In response to committee member feedback, several key design moves have occurred which aim to enhance how the building form meets the Ground. These key moves look to improve the amenity space offering for building occupants, increase the public realm, and increase engagement of the building with the public realm. Simultaneously, these design moves look to add 'clarity of design form' to improve users' and passersby' overall understanding of the proposal. The following sketches articulate these key design moves.

Ground Floor

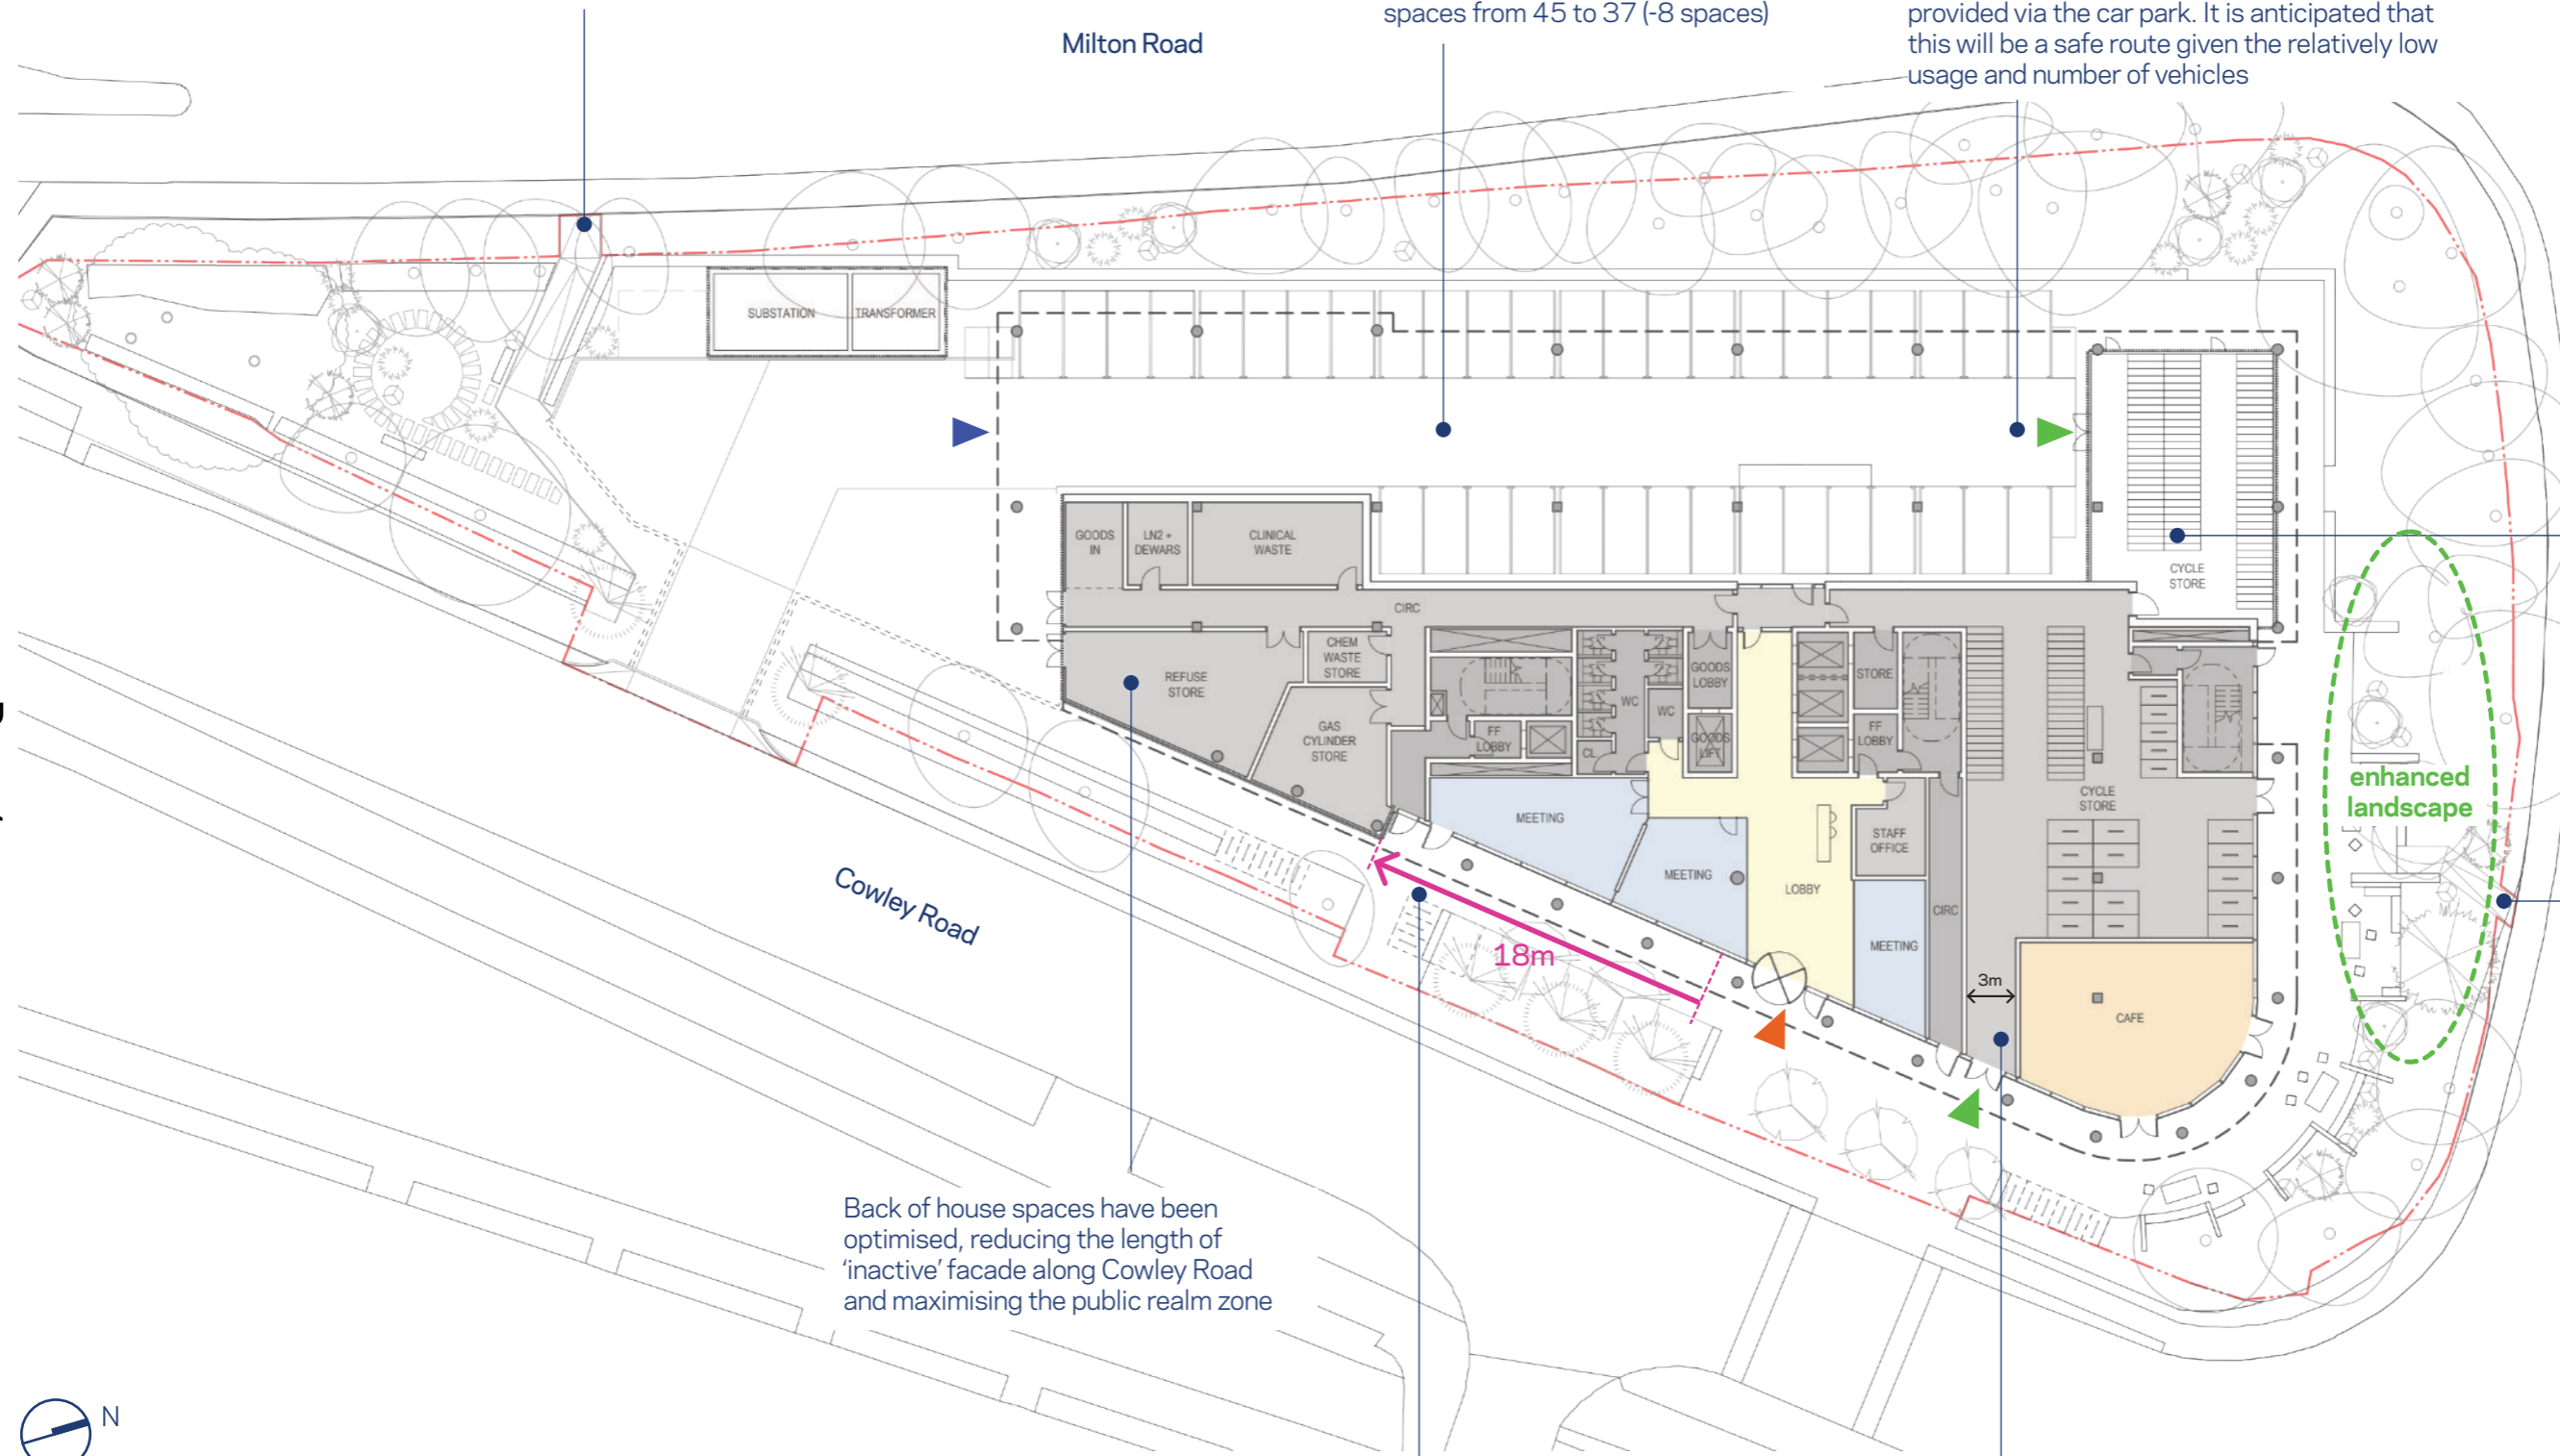
Review hierarchy of access route for cyclists

Look at internal integration of cycle parking

Concern over steps in landscape

Review hierarchy of access route for cyclists

A secondary access for cyclists has been provided via the car park. It is anticipated that this will be a safe route given the relatively low usage and number of vehicles

All long-stay bicycle parking has been shifted to within the building footprint, some visitor spaces are located in the landscape on Cowley Rd

Accessible ramps have now been added to the landscape and all steps removed

Back of house spaces have been optimised, reducing the length of 'inactive' facade along Cowley Road and maximising the public realm zone

Colonnade has been extended an additional 18m further to the south, increasing the active edge to Cowley Road and maximising the public realm zone

North-east view

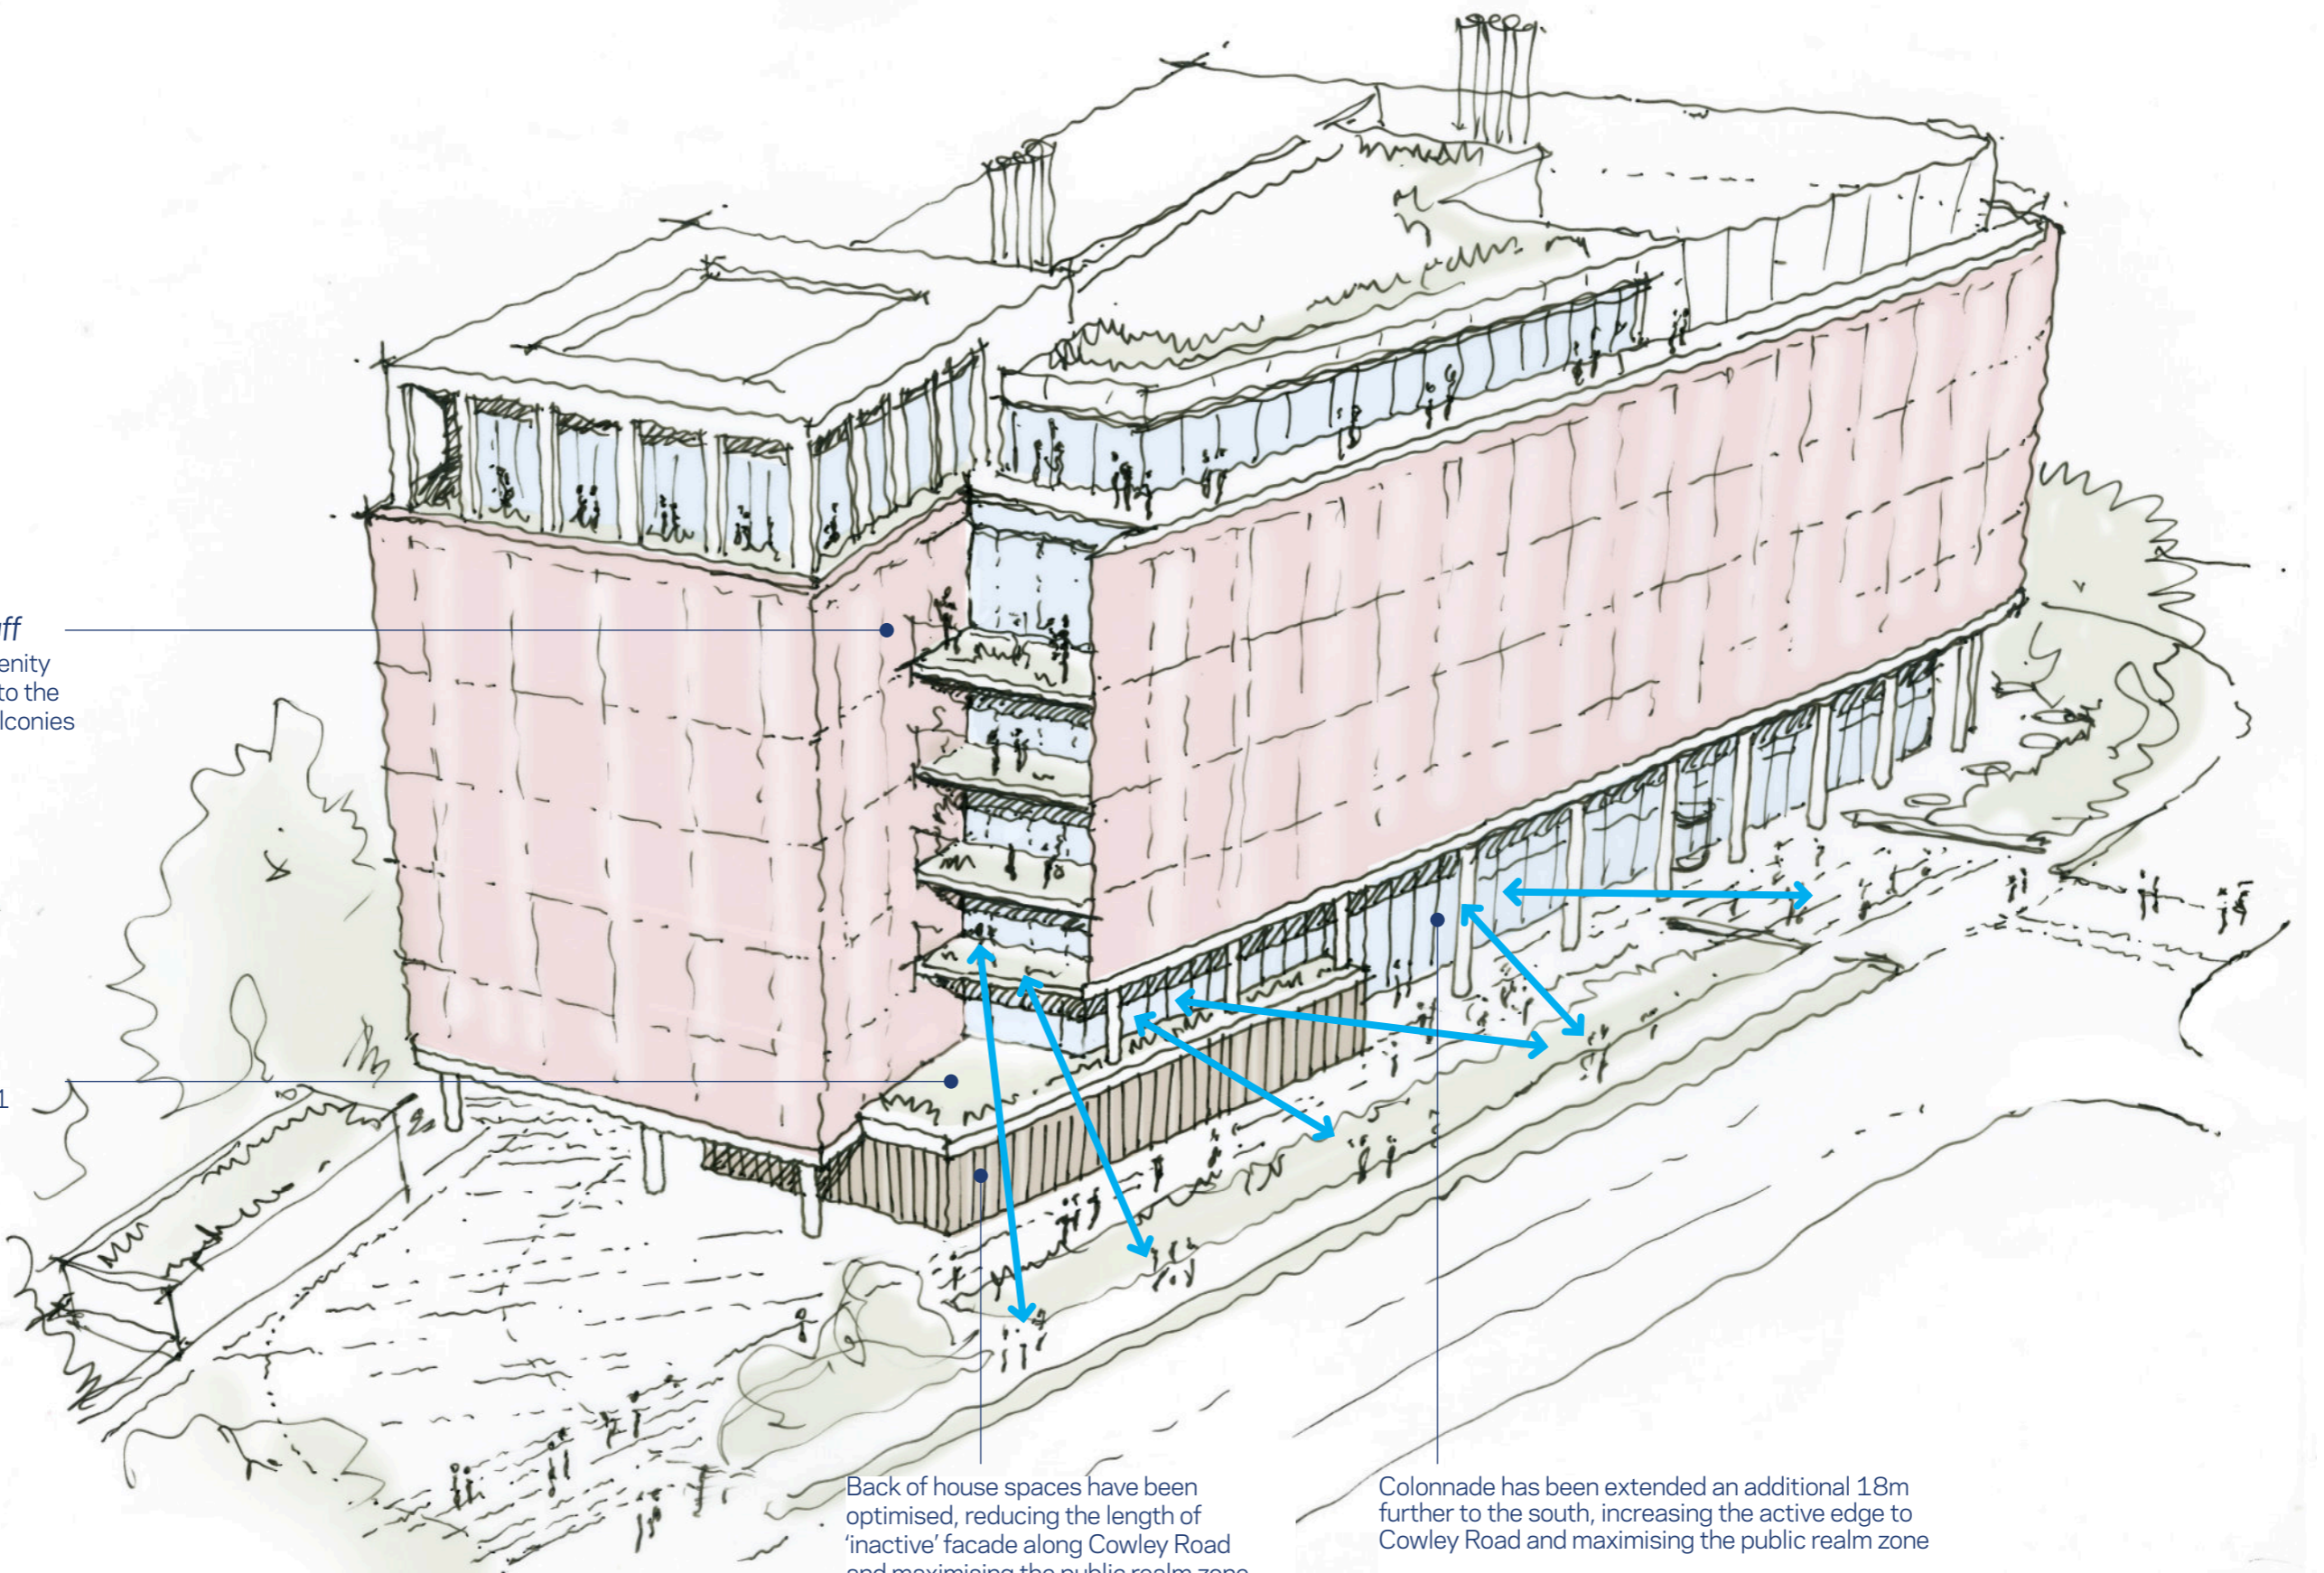
Review hierarchy of access route for cyclists

Back of house spaces have been optimised, reducing the length of 'inactive' facade along Cowley Road and maximising the public realm zone

Colonnade has been extended an additional 18m further to the south, increasing the active edge to Cowley Road and maximising the public realm zone

Primary cycle entry shifted to Cowley Road East, via a 3m entrance corridor, adjacent to main pedestrian entry. Secondary cycle entrance via the car park

Landscape - Retaining existing trees

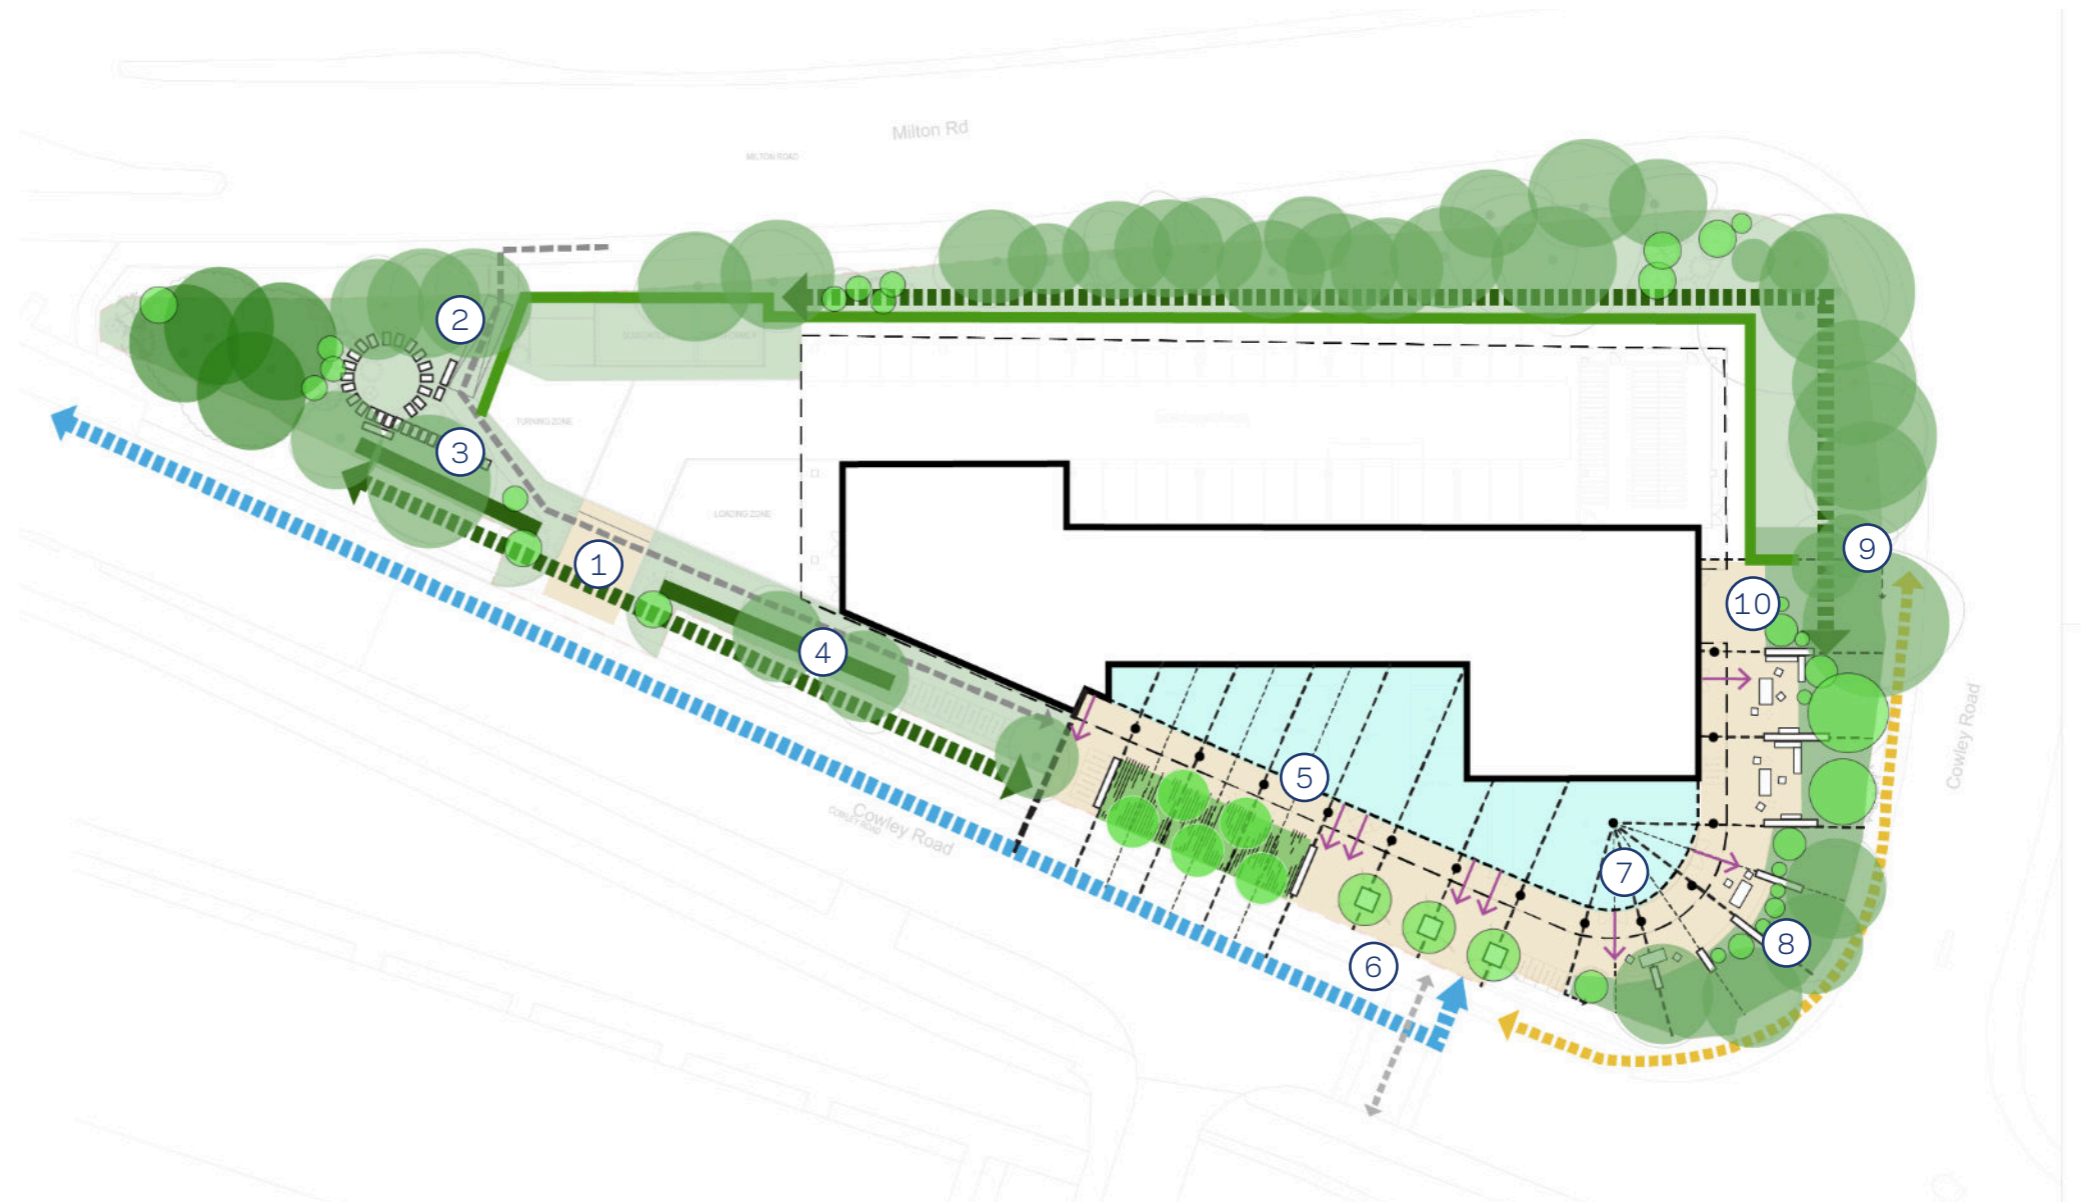
Provide some commentary on tree removal and new landscaping

- Retain additional existing trees and hedging along Cowley Road
- Protect and preserve the root infrastructure to retained existing trees across the site
- Ensure new planting is sufficient in enhancing, and improving the biodiversity on site
